**CENTRAL BEDFORDSHIRE COUNCIL COMMENTS ON DEADLINE 6
SUBMISSIONS**

LONDON LUTON AIRPORT EXPANSION DEVELOPMENT CONSENT ORDER

Version – FINAL

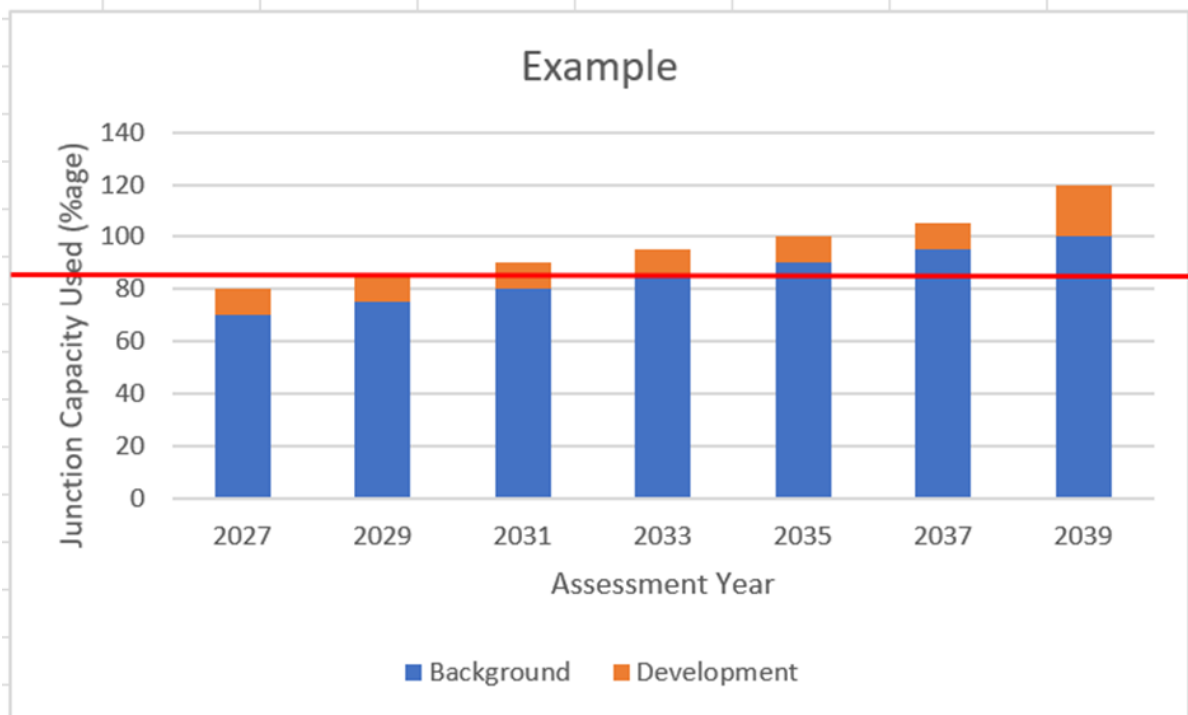
It appears that CBCs concerns on this matter may have been misinterpreted. It is understood that the OTRIMMA outlines those works necessary to mitigate the impacts of development traffic rather than background traffic, however the concern is that a set level of development traffic could trigger the need to mitigation due to an increase in the background levels of traffic over time (and would not be captured under the current proposals), as shown in the example below.

In this indicative example the growth associated with the airport is shown in orange, whilst background growth is shown as the blue element of each column. As can be seen in this example, the initial growth in 2027 doesn't push the junction over 85% capacity (as the generally applied threshold for reasonable operation), however as background traffic grows between 2029 and 2039, (which is potentially the next period when there would be a guaranteed increase in passenger throughput), the junction operates over capacity, from 2031 onwards, with the growth associated with the airport being responsible for taking the junction over capacity. Under the current proposals there would potentially be no requirement to re-assess the junction until throughput increases in 2039, by which time the junction would have been operating over capacity for 8 years.
